UNITED STATES PATENT AND TRADEMARK OFFICE

Office Action Summary	Application No. 10/029,394	Applicant(s) KIM ET AL.	
	Examiner KHIEM D. NGUYEN	Art Unit 2823

DETAILED ACTION

FIGURE 9b

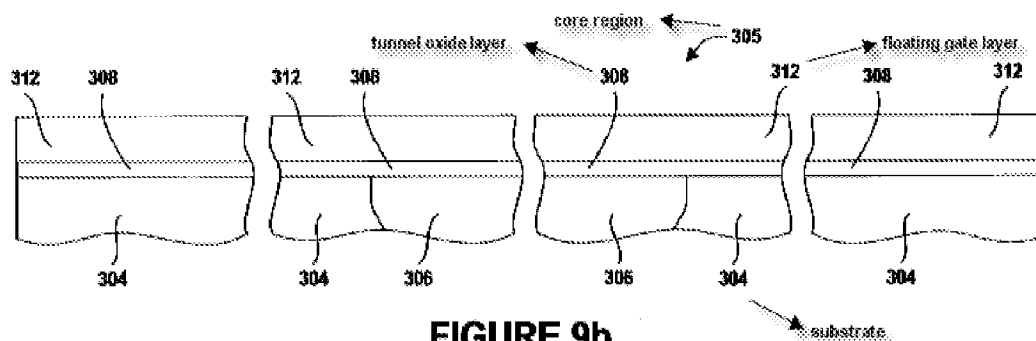
forming a tunnel oxide layer **308** and a floating gate layer **312** on a semiconductor substrate **304** including a cell region and a distinct peripheral region (see col. 9, lines 32-42 and FIG. 9b);

FIGURE 9c

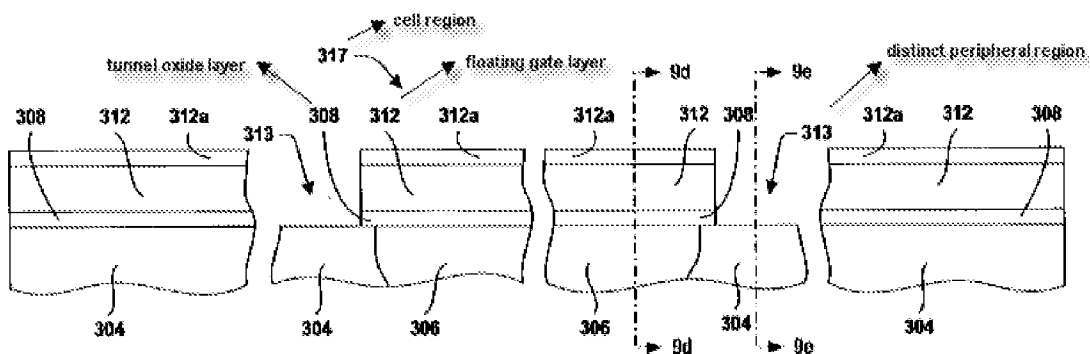
removing the floating gate layer **312** and the tunnel oxide layer **308** formed on the distinct peripheral region **313** (see col. 9, lines 43-56 and FIG. 9c);

FIGURE 9f

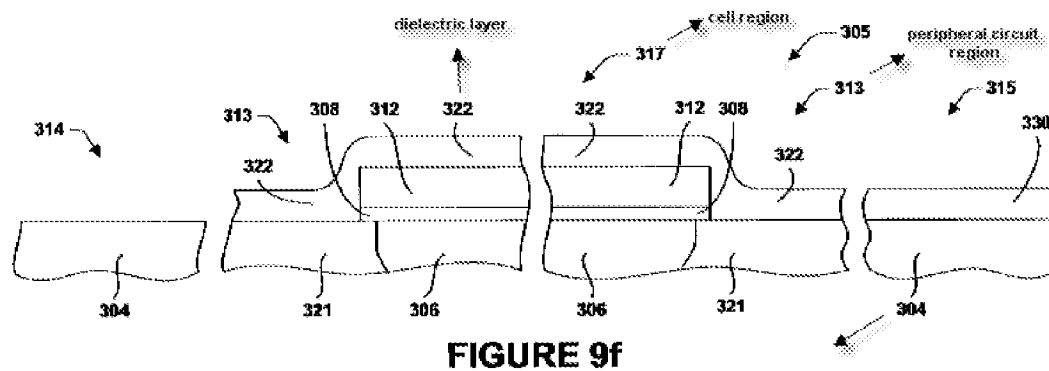
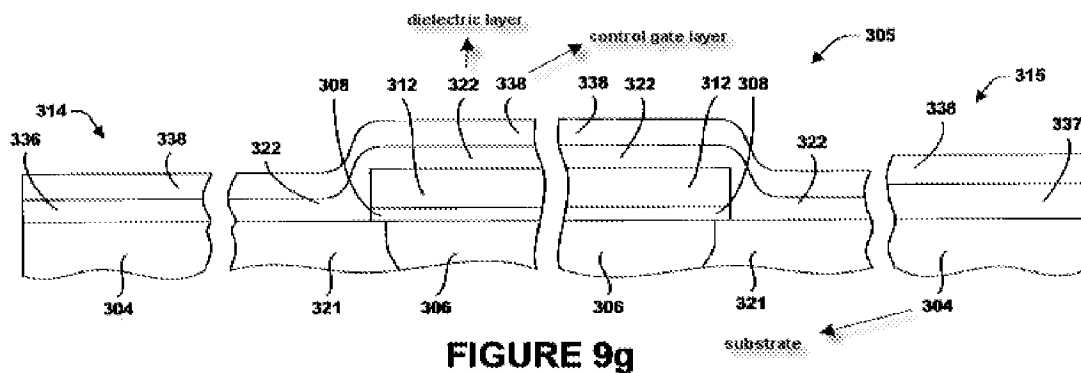
forming a dielectric layer **322** and a control gate layer **338** on the cell region **317** and the peripheral circuit region **313** of the semiconductor substrate **304**, the dielectric layer **322** including an oxide layer and a nitride layer (oxide/nitride/oxide, ONO layer), (see col. 10, lines 29-65 and FIGS. 9f-g);

FIGURE 9i

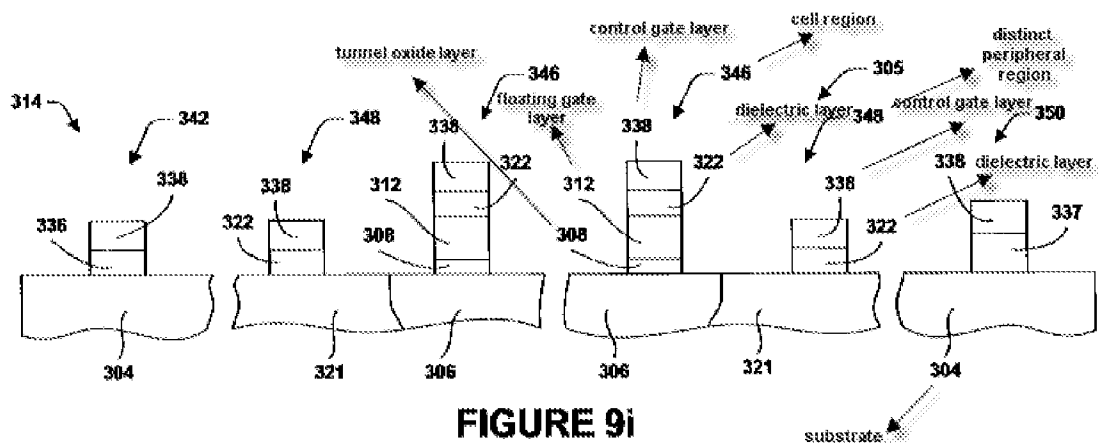
patterning the control gate layer **338**, the dielectric layer **322**, the floating gate layer **312** and the tunnel oxide layer **308** to form a stack gate on the cell region **346** and a gate including the control gate layer **338** and the dielectric layer **322** on the distinct peripheral region **348** (see col. 11, lines 6-19 and FIG. 9i); and

FIGURE 7a

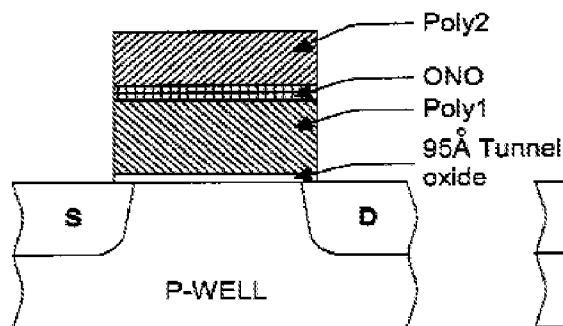
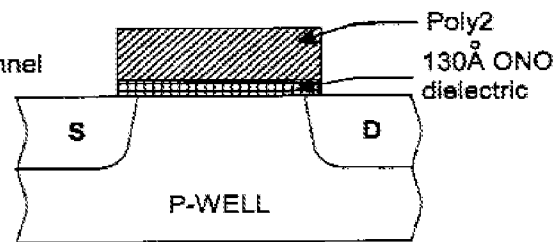
forming a source **S** and a drain **D** region in the semiconductor substrate by performing an impurity ion implantation process (see FIGS. 7a-b).

FIG. 6

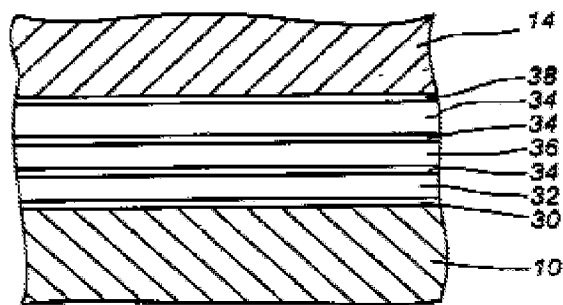
Sheng et al., disclose an insulating structures used in DRAMs or other memory devices such that the dielectric layer is formed by stacking a first oxide layer **30**, a first nitride layer **32**, a second oxide layer **34**, and a second nitride layer **36** (ONON) between the lower doped polysilicon electrode **10** and the upper doped polysilicon electrode **14** (see col. 7, line 56 to col. 8, line 49 and FIG. 6).

As Sheng et al. disclose, one of ordinary skill in the art would have been motivated to provide a dielectric layer formed by stacking a first oxide layer, a first nitride layer, a second oxide layer, and a second nitride layer (ONON) because such repeated layer structures exhibit higher levels of breakdown voltage than more conventional “ONO” structures thereby improving device characteristics (see Abstract of Sheng et al.).

FIG. 6

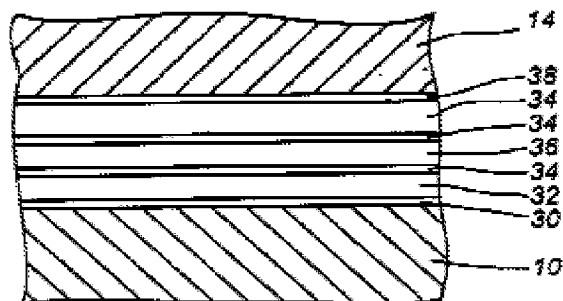
Sheng et al., disclose an insulating structures used in DRAMs or other memory devices such that the dielectric layer is formed by stacking a first oxide layer **30**, a first nitride layer **32**, a second oxide layer **34**, a second nitride layer **36**, and a third oxide layer **34**, (ONONO) between the lower doped polysilicon electrode **10** and the upper doped polysilicon electrode **14** (see col. 7, line 56 to col. 8, line 49 and FIG. 6).

As **Sheng et al.** disclose, one of ordinary skill in the art would have been motivated to provide a dielectric layer formed by stacking a first oxide layer, a first nitride layer, a second oxide layer, a second nitride layer and a third oxide layer (ONONO) because such repeated layer structures exhibit higher levels of breakdown voltage than more conventional "ONO" structures thereby improving device characteristics (see Abstract of Sheng et al.).

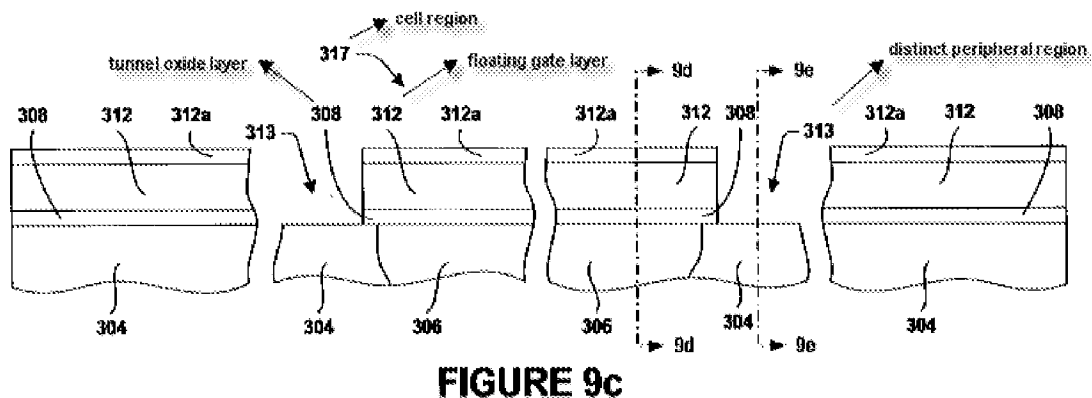
forming a tunnel oxide layer **308** and a floating gate layer **312** on a semiconductor substrate **304** including a cell region and a distinct peripheral region (see col. 9, lines 32-42 and FIG. 9b);

removing the floating gate layer **312** and the tunnel oxide layer **308** formed on the distinct peripheral region **313** (see col. 9, lines 43-56 and FIG. 9c);

FIGURE 9f

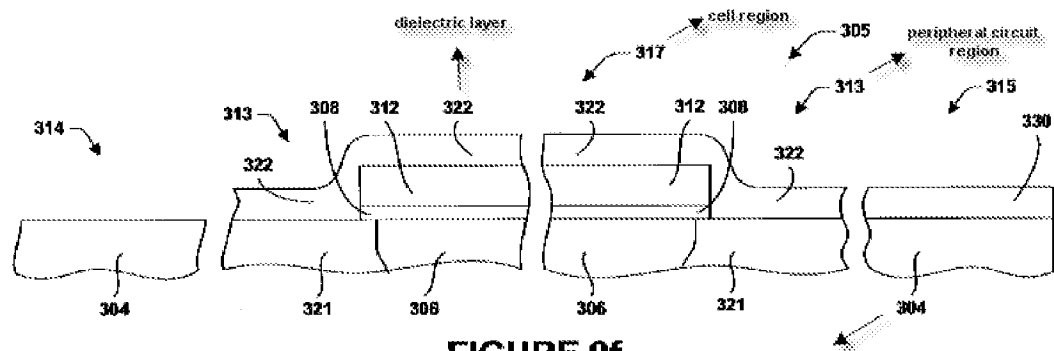
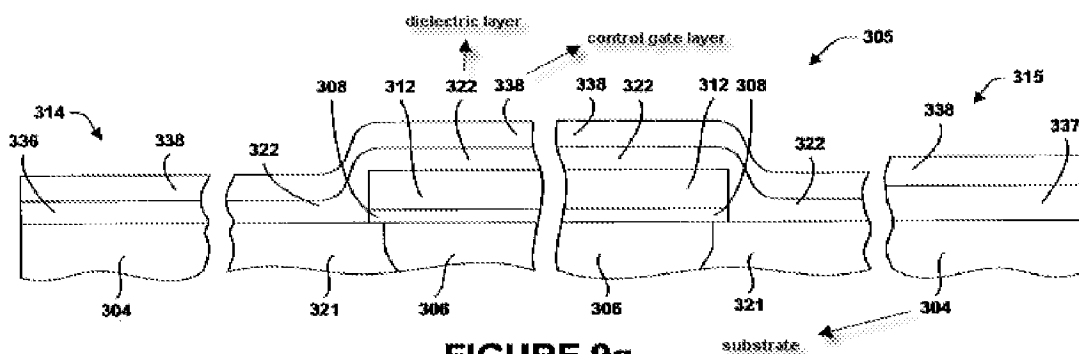
forming a dielectric layer **322** and a control gate layer **338** on the cell region **317** and the distinct peripheral region **313** of the semiconductor substrate **304**, the dielectric layer **322** including a first oxide layer, a first nitride layer, and a second oxide layer (oxide/nitride/oxide layer, ONO) (see col. 10, lines 29-65 and FIGS. 9f-g);

FIGURE 9i

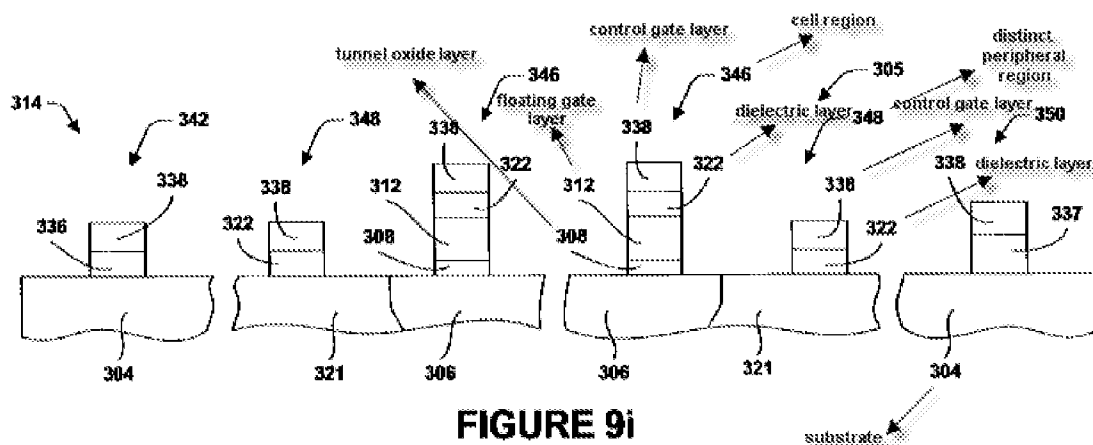
patterning the control gate layer 338, the dielectric layer 322, the floating gate layer 312 and the tunnel oxide layer 308 to form a stack gate on the cell region 346 and a gate including the control gate layer 338 and the dielectric layer 322 on the distinct peripheral region 348 (see col. 11, lines 6-19 and FIG. 9i); and

FIGURE 7a

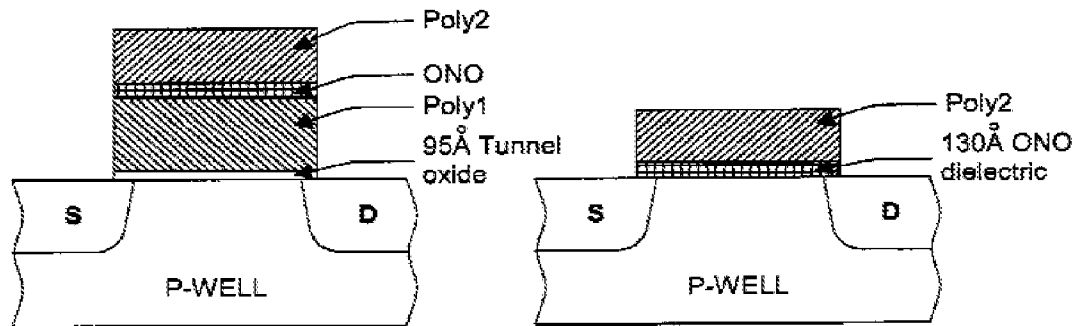
forming a source **S** and a drain **D** region in the semiconductor substrate by performing an impurity ion implantation process (see FIGS. 7a-b).

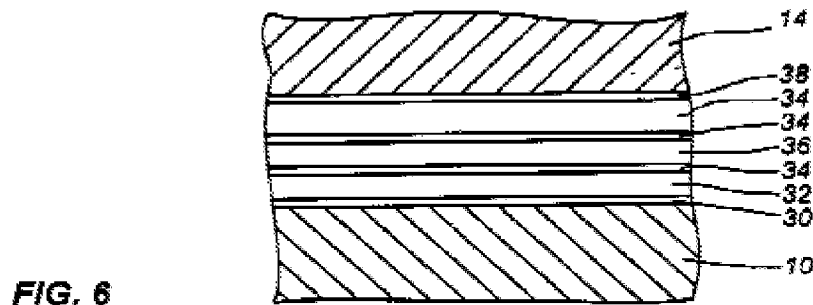
However, Fang does not specifically disclose that the dielectric layer including a first oxide layer (O), a first nitride layer (N), a second oxide layer (O), a second nitride layer (N), and a third oxide layer (O), (ONONO).

Sheng et al., disclose an insulating structures used in DRAMs or other memory devices such that the dielectric layer is formed by stacking a first oxide layer **30**, a first nitride layer **32**, a second oxide layer **34**, a second nitride layer **36**, and a third oxide layer **34**, (ONONO) between the lower doped polysilicon electrode **10** and the upper doped polysilicon electrode **14** (see col. 7, line 56 to col. 8, line 49 and FIG. 6).
